Door Check Arm Noise

Service Category Vehicle Exterior

Section Door/Hatch

Introduction

Figure 2.

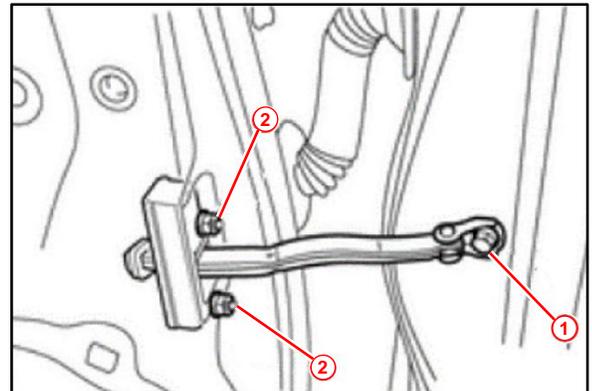
3. Confirm the torque value of the 3 check arm mounting fasteners:

Bolt (1):

Torque: 29 N*m (296 kgf*cm, 21 ft*lbf)

Nuts (2):

Torque: 8.5 N*m (87 kgf*cm, 75 in*lbf)

1	Bolt
2	Nut (2)
